TITLE: **AP1000 DCD Impacts to Support COLA Standardization**

**APP-GW-GLR-134**  
**Revision 0**

# **AP1000 Standard Combined License Technical Report**

## **AP1000 DCD Impacts to Support COLA Standardization**

Figure 3H.5-9 (Sheet 1 of 3)

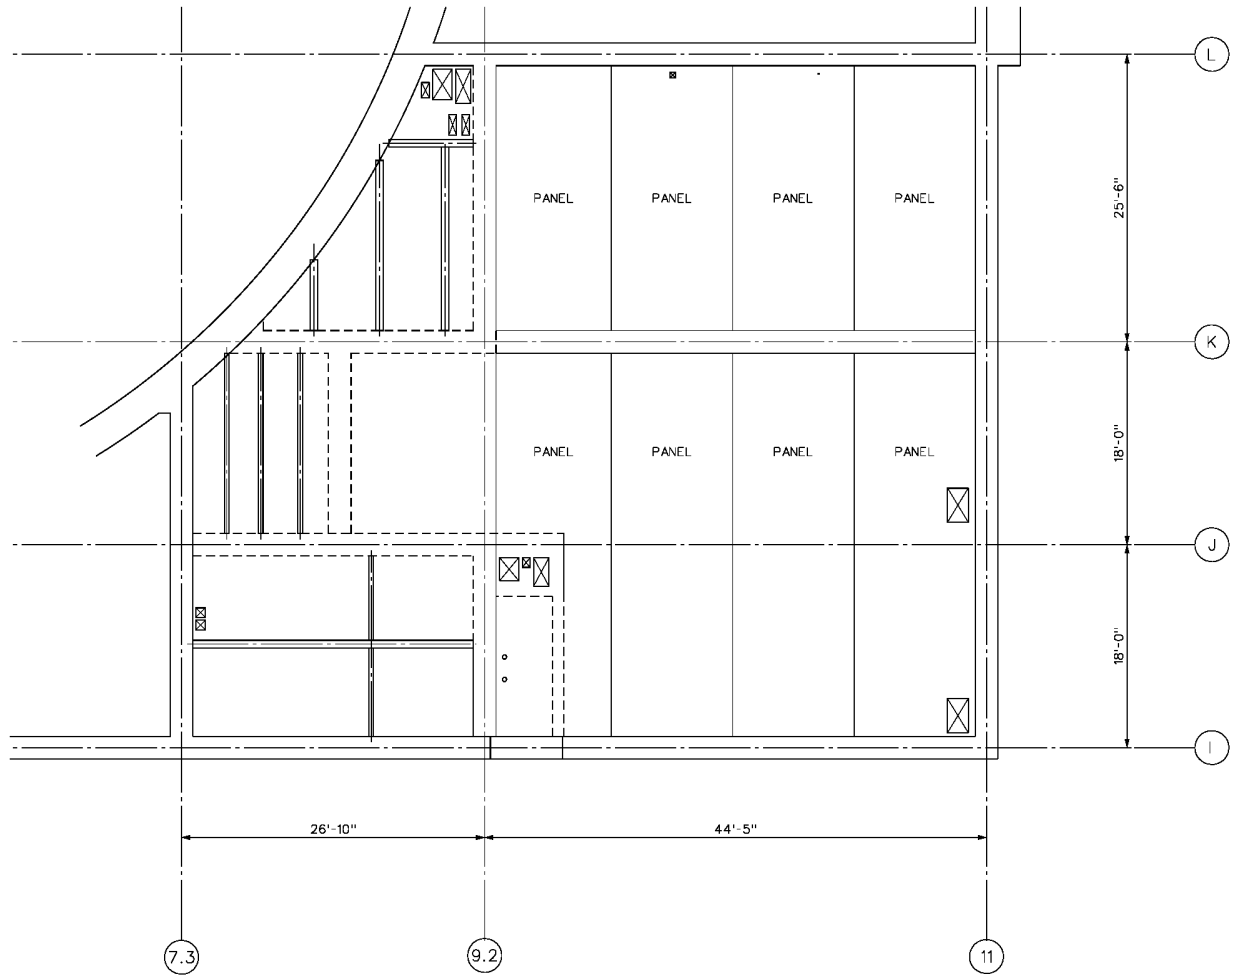
**NRC 094 contains corrections to Figure 3H.5-9 sheet 1 and Figure 3H.5-12 of the DCD Revision 16 to be consistent with TR 57, APP-GW-GLR-045, Rev 0.**

Figure 3.8.2-4 (Sheet 2 of 6)

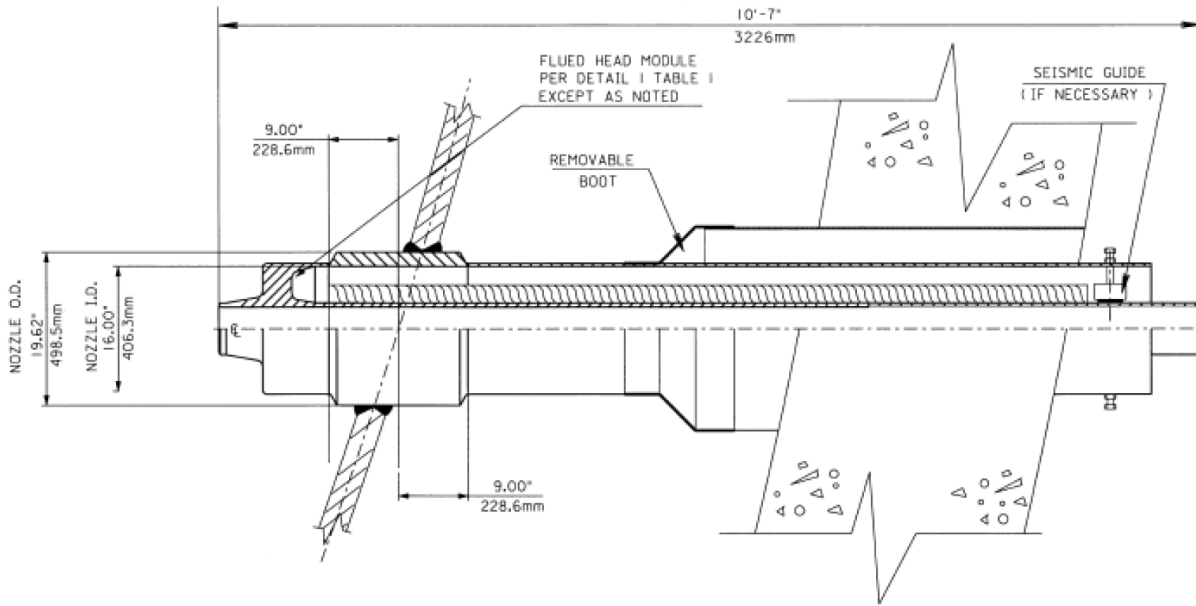
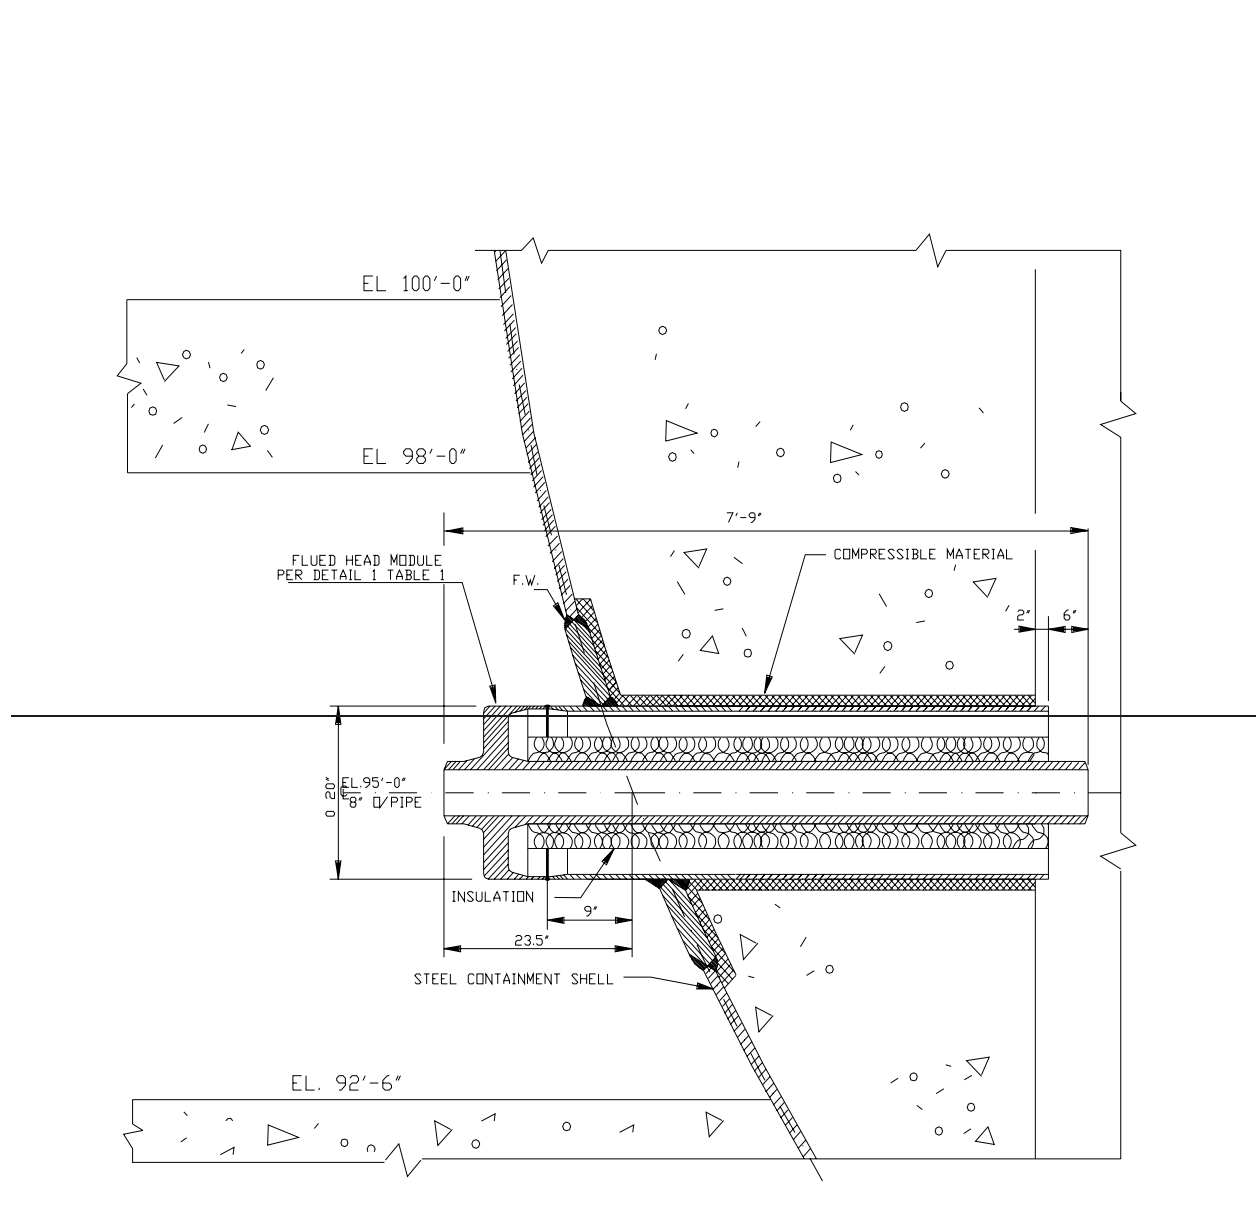
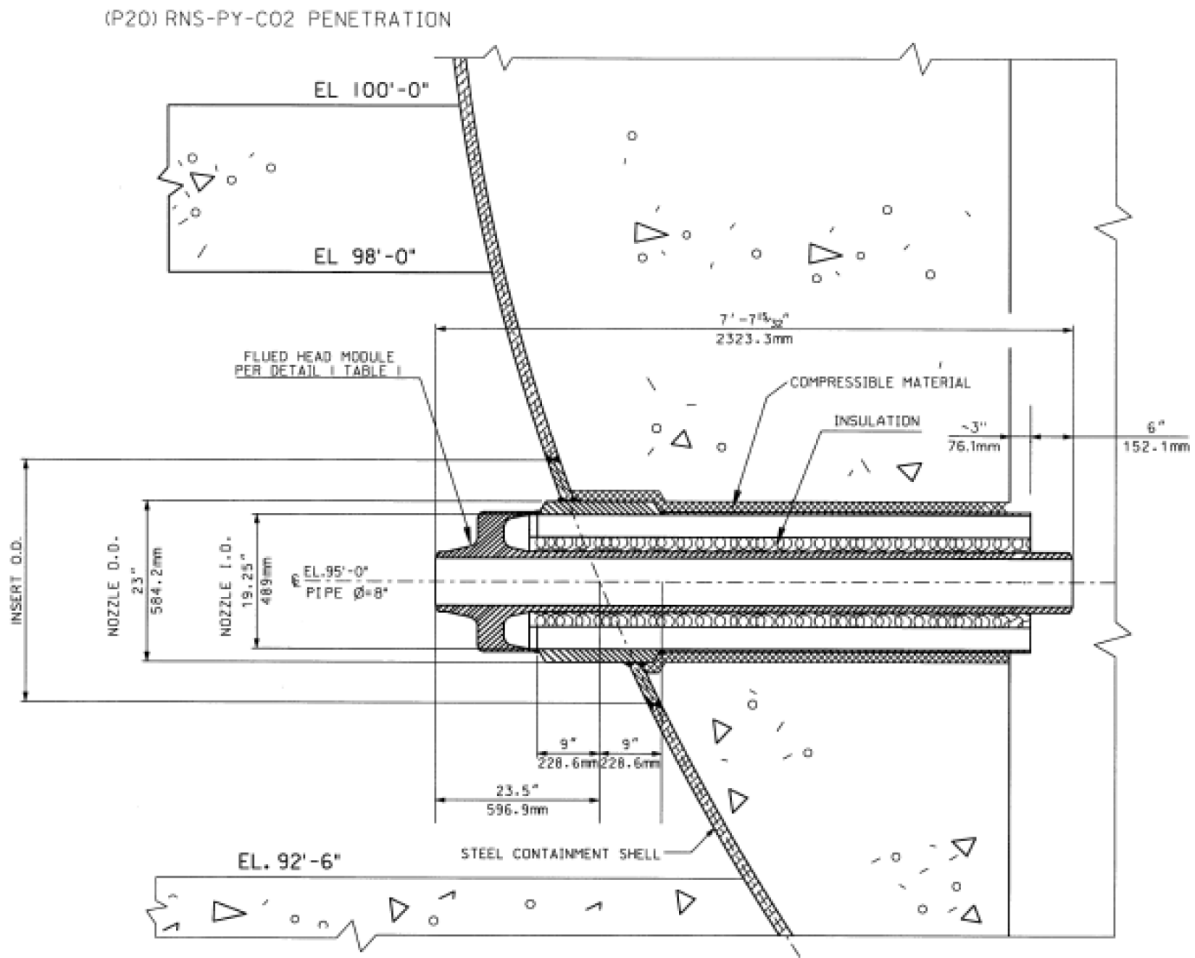
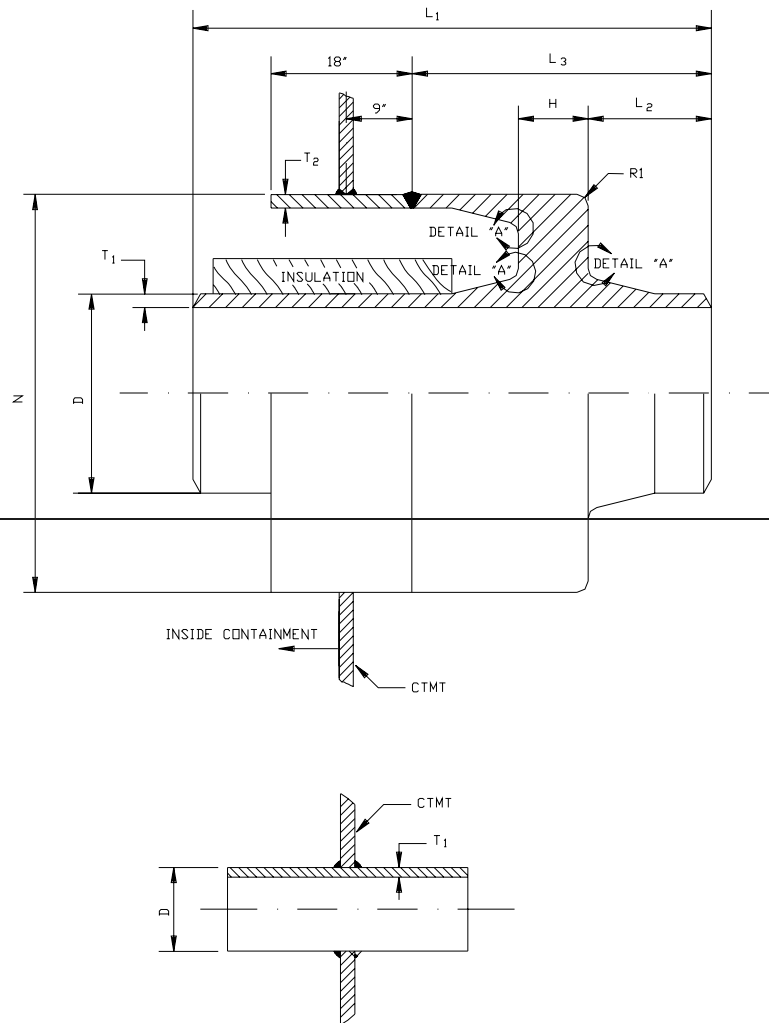
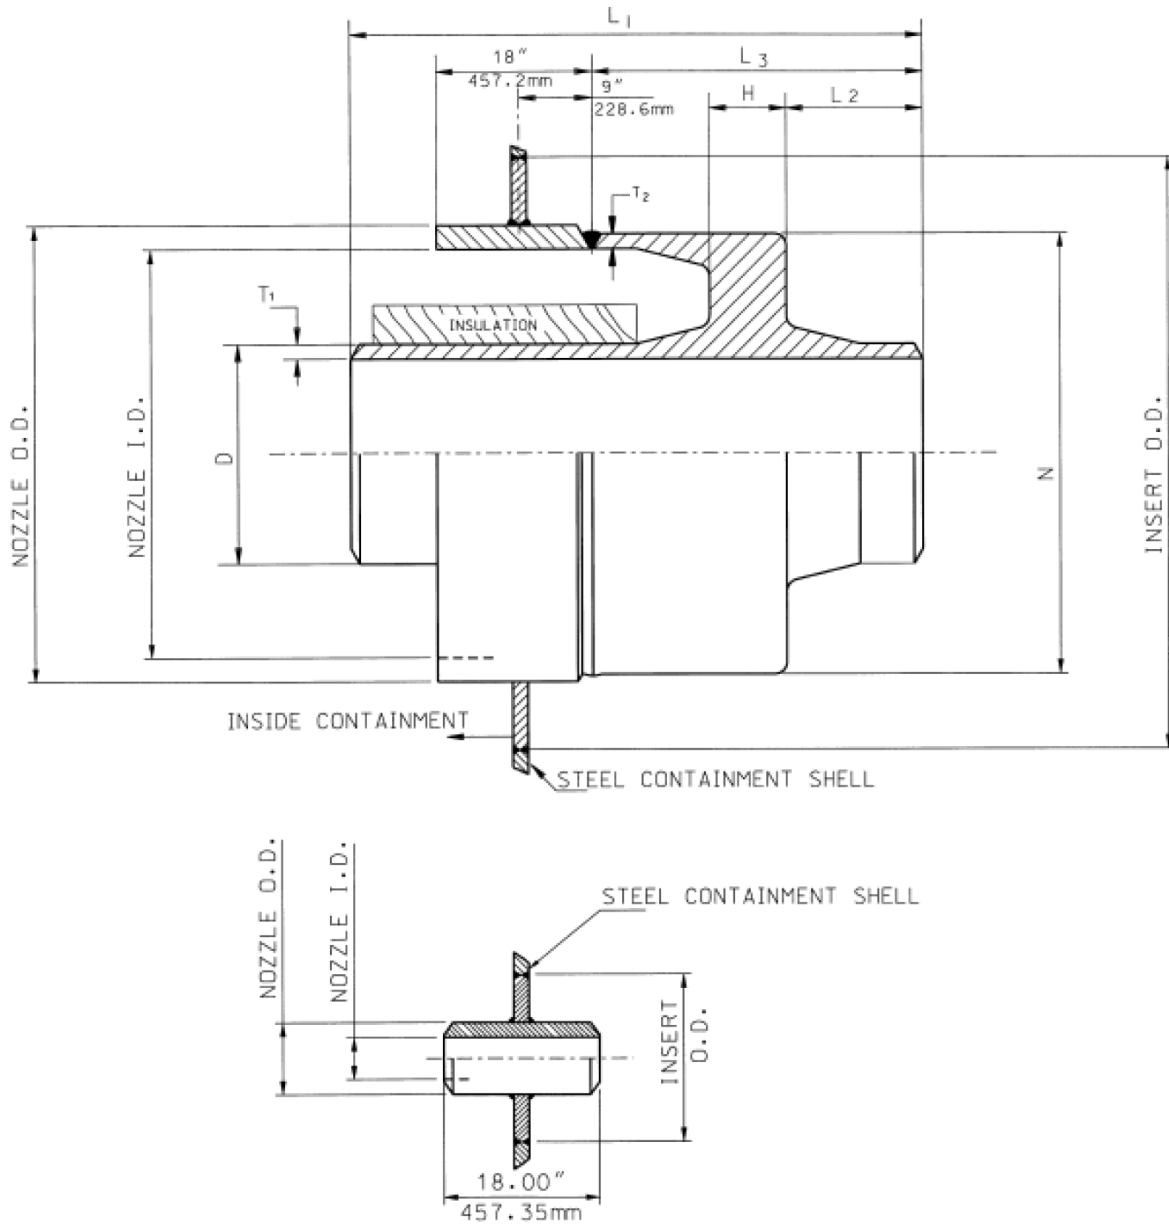
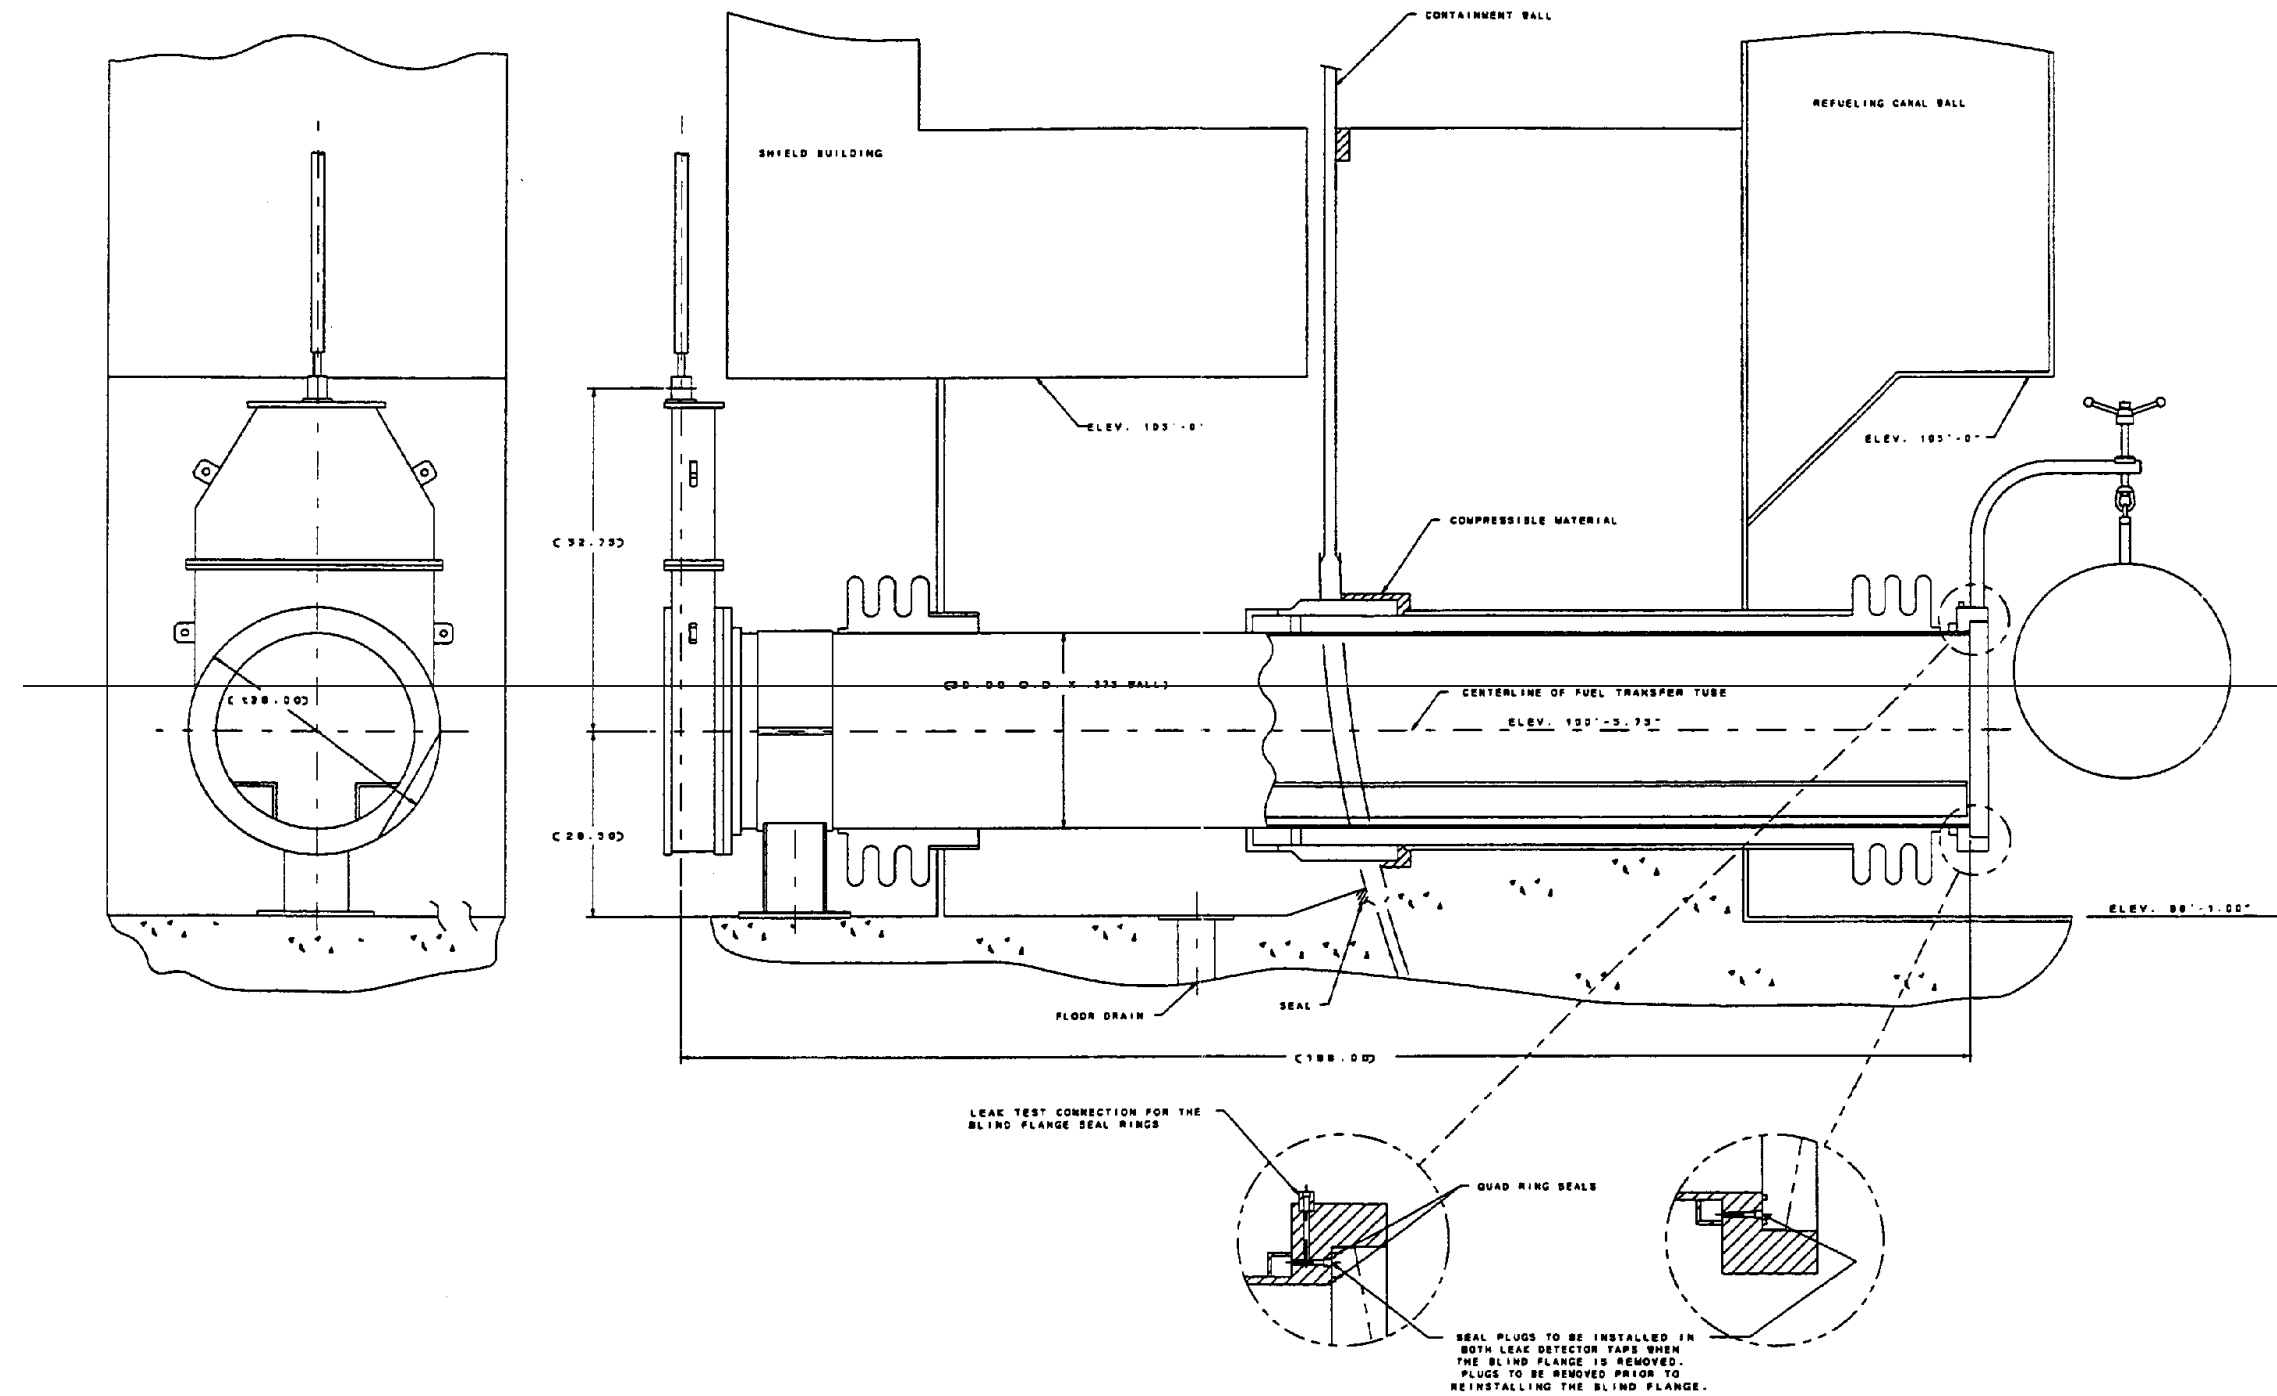
**NRC044 contains corrections to Table 3.2-3, Figure 3.8.2-4 of DCD Revision 16. The basis for the change is RAI-TR09-003.**

Figure 3I.1-1

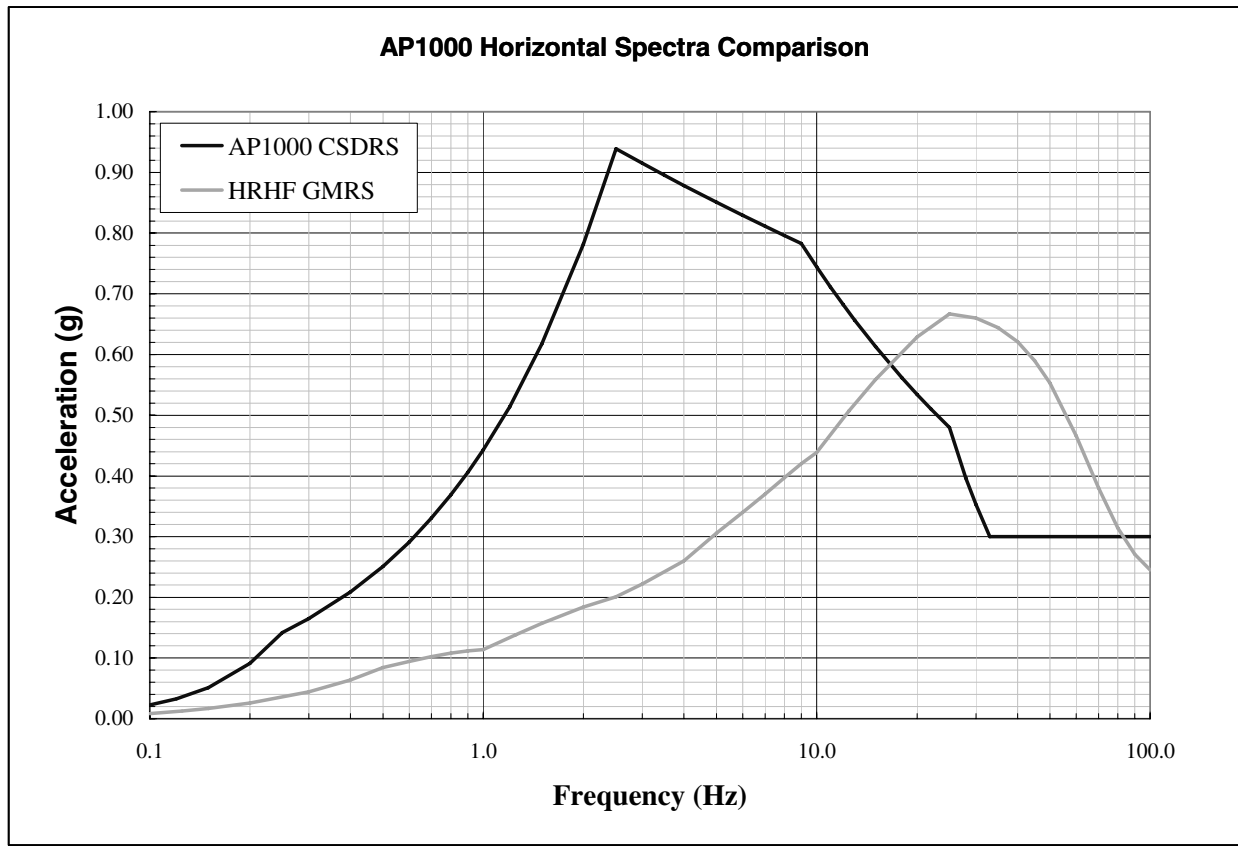
NRC 163
